## Electronic Silk Road (Shenzhen) Tech Co., Ltd

### Declaration of Product Modifications

This is to request a Class II permissive change for FCC ID: 2APEW-2B513 originally granted on 06/28/2023.

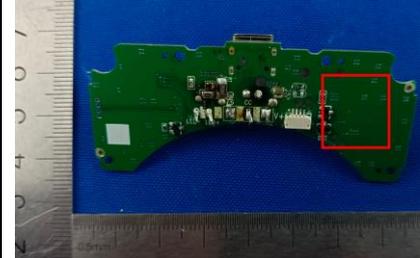
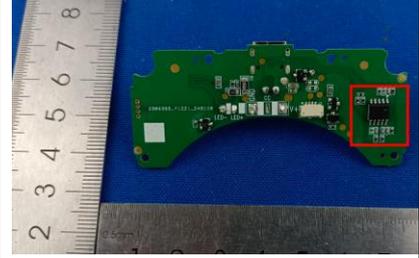
The reasons for the changes in this application are as follows: added the control chip ETA7906, changing partial EMC peripheral circuitry that doesn't affect the RF performance. The Radiated emissions (Below 1GHz) are tested for differences, MPE retested according to the new KDB 680106 test method, The report replace the difference data and new sample photos.

before	after	Change content
		added the control chip ETA7906
